**Committee on
Housing
(AC-Ho)**

➤ **03hr_AC-Ho_Misc_pt03b**

To: Bill Seibers
From: Jim Dallman *Jim*
CC: Carl Scott, Architect
Date: 02/04/03
Re: 411 West college Avenue

RE: 411 West College Avenue
Construction Meeting 11/19/02

EXAMPLES: Firewall penetrations need to be properly firestopped.

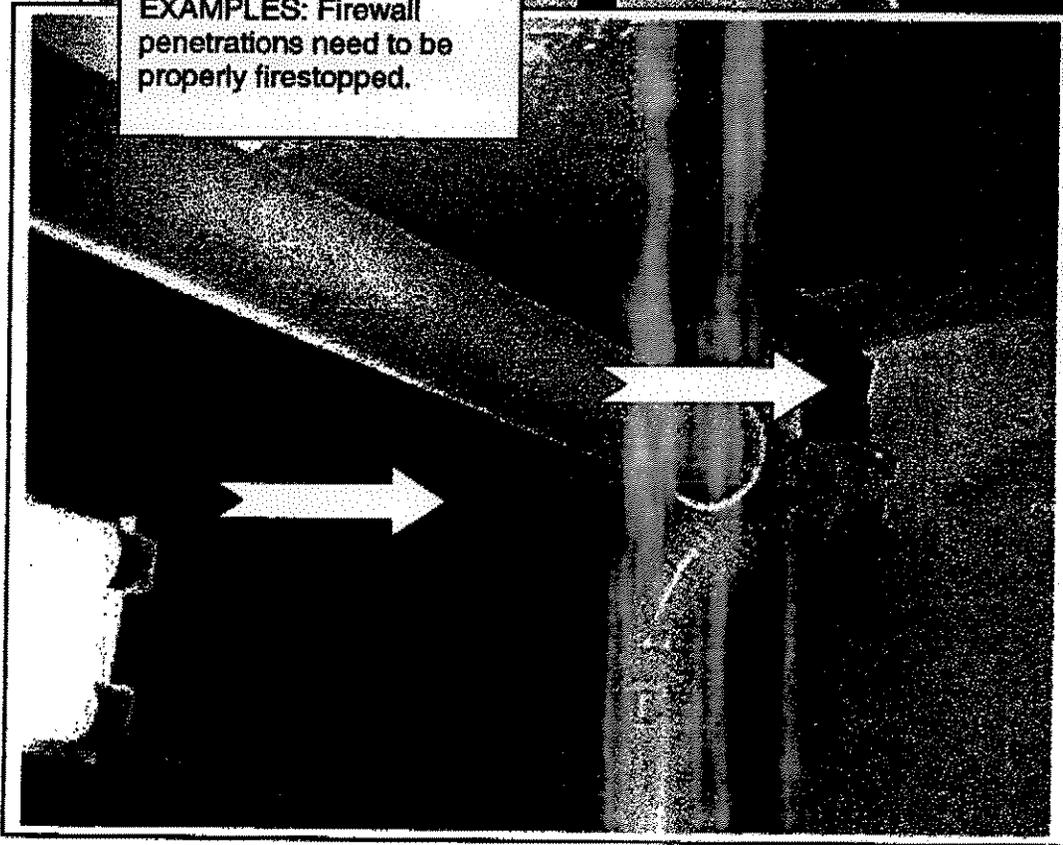
- Modify the steel beam in the basement per the architect's specification (see attachment)
- Firestop all penetrations and wall joints (see attached examples)

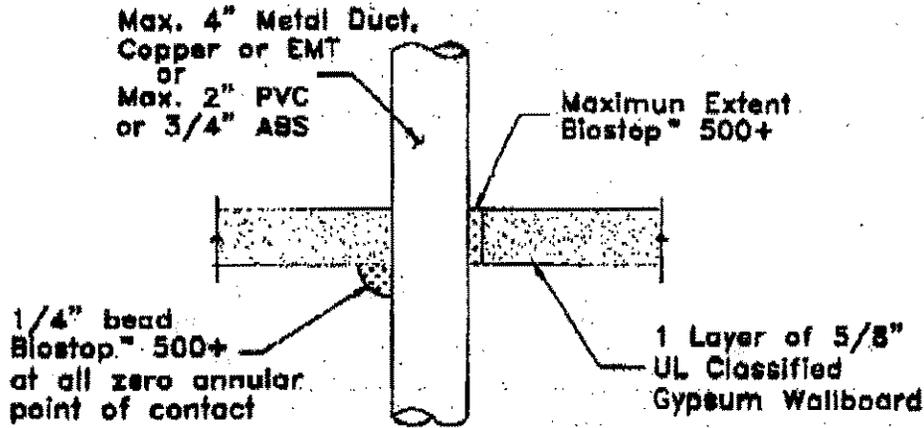
Please find enclosed our installation instructions marked 02-12-09. These installation instructions have been developed from, but are not limited to, data gained from tests we have conducted or from tests such as ASTM E 814, UL 1479 or UL 2079, conducted by nationally recognized, independent testing laboratories (such as: UL®; Warnock Hersey, Factory Mutual, Omega Point, etc.). We also rely on years of experience relating to both the performance characteristics of our products as well as an extensive knowledge of firestopping technology. Each installation instruction is given according to your own individual and unique set of circumstances. Instructions done for one job site condition may not be the same as those given for another. Therefore, these instructions are applicable only for the job it was originally given to and should not be used for any other condition until approved by our Technical Services Department. We, here at RectorSeal, thank you for using our products. If you have any additional questions, please call our office at 1-800-231-3345.

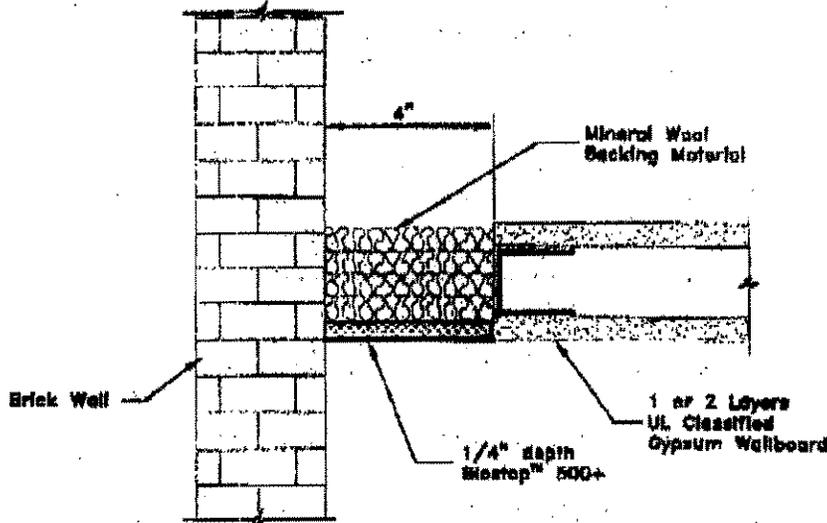
1. Properly install and secure into place a 4"-6" depth of min. 4.0 pcf mineral wool insulation into all gaps and voids. Insulation should be installed with top surface flush with the top of the slab.

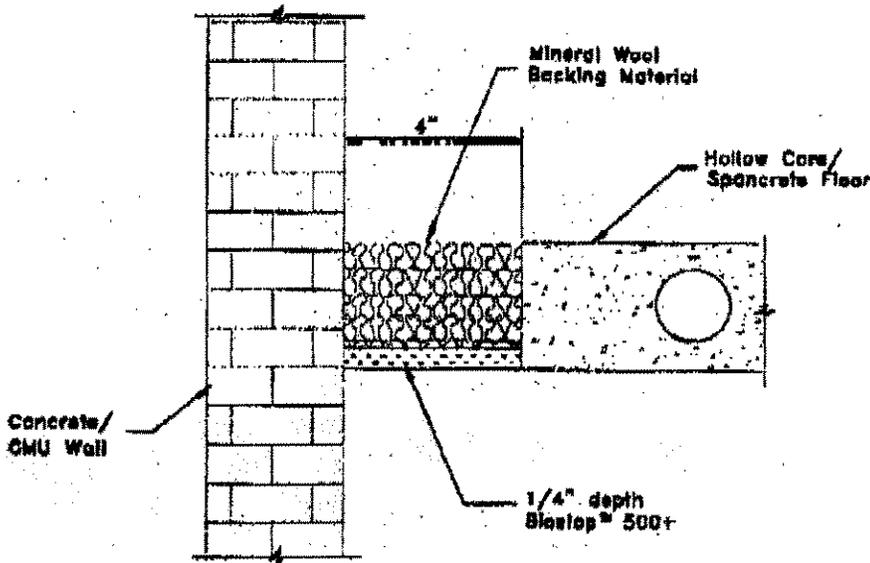
1) With any gaps larger than 1" - Properly install and secure into place a full floor depth of min. 4.0 pcf mineral wool insulation into all gaps and voids. Insulation should be installed with top surface flush with the top of the slab. If mechanically fastening is not applicable, insulation may be cut over size and friction fit, to insure that insulation is firmly in place.

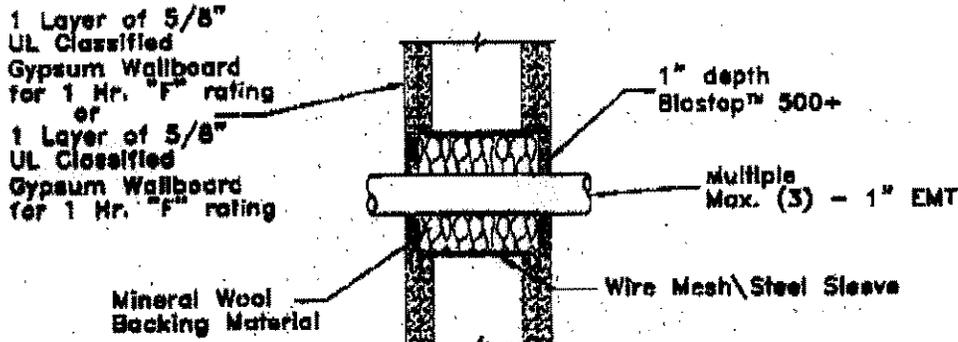
- 1) Install No. 8 wire mesh or min. 20ga. galvanized steel sleeve cut to size, formed to hole shape, centered inside wall around pipe, and allowed to spring back snugly against periphery of hole such that it is recessed a min. of 1/8" in from wall surface on both sides.
- 2) Install backing material by firmly packing annular space with full wall of depth of min. 4.0 pcf mineral wool. Recess backing material at least 1" in from both sides of wall to accommodate the required fill depth of Biostop™ 500+.
- 3) Gun, trowel and/or pump Biostop™ 500+ firestopping sealant to a 1" depth on both sides of wall. Trowel sealant surfaces flush with wall surfaces and to a smooth defect-free finish.

Drawing No. B-12-09d

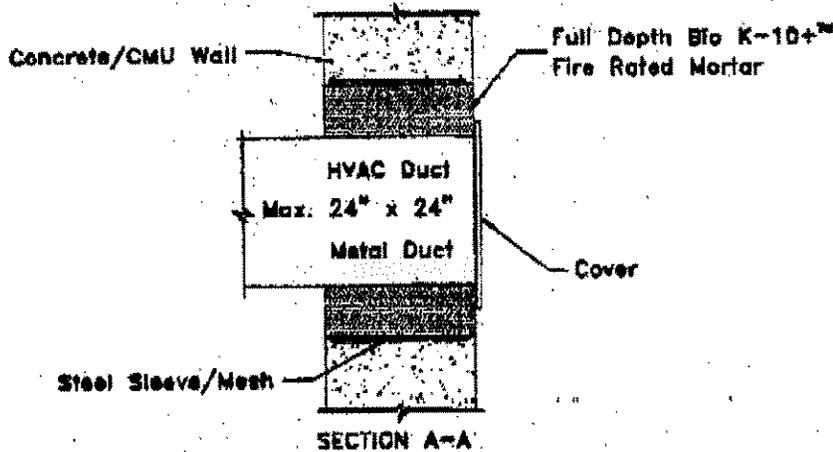
MAX: 24" x 24" METAL DUCT - MIN. 20GA. HOURLY RATING: 1 OR 2 HOUR "F" RATING ANNULAR SPACE: NOMINAL 0"	JOB NO.: 02-12-09d JOB NAME: SOMETHING SWEET CONTRACTOR: CONTRACTING SPECIALIST DISTRIBUTOR: L.W. MEYER REPRESENTATIVE: ADAM KNUTH CO., INC. 12020 W. PEBBICK STREET MILWAUKEE, WI 53222 MR. KEVIN KNUTH (214) 466-2400
<div style="border: 1px solid black; padding: 2px; font-size: 8px;"> ALL technical information contained herein is based on information furnished to us which we believe to be accurate and complete. The drawings are issued as the structural department's and contractor's job site conditions and/or requirements furnished to us by a third party and should be read carefully. Reported errors include the function of the product if included as shown in this drawing. It is recommended that the user check drawings of the operating product, systems, and/or supplier's building instructions for the correct future installation. For further product warranty, refer to specific Product Data Sheet(s). </div>	FOR QUALIFIED INSTALLERS: UL AND/OR WARNER MERRY C-10001-100000 CAJ2014 CAJ8005, CAJ1032 DATE: 02-04-03 TECH: MARK MALAY

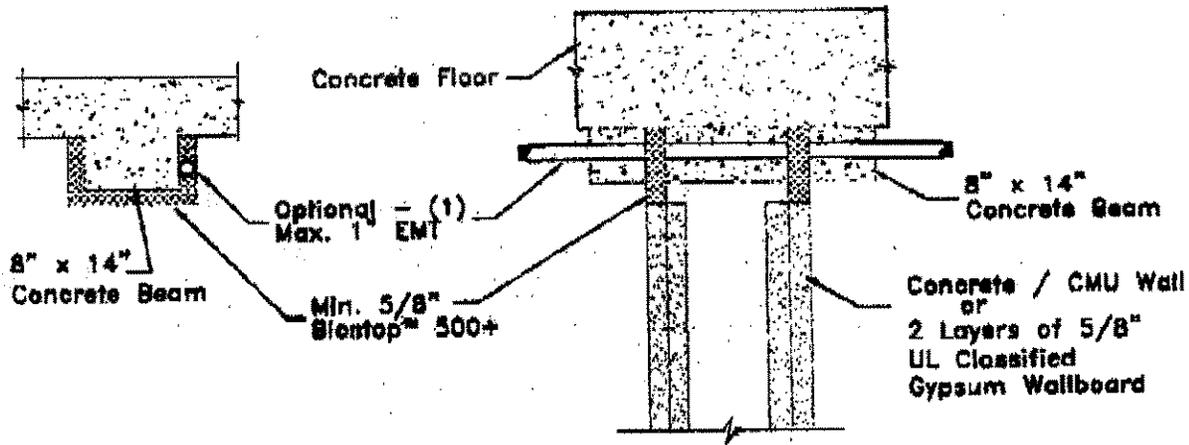
Gun, trowel, and/or pump Biostop™ 500+ firestopping sealant to a min. 5/8" depth into the gap on both sides of wall around the concrete beam. Apply a continuous 1/2" bead at all zero-annular areas. Trowel sealant surface flush with wall surface and to a smooth defect-free finish.
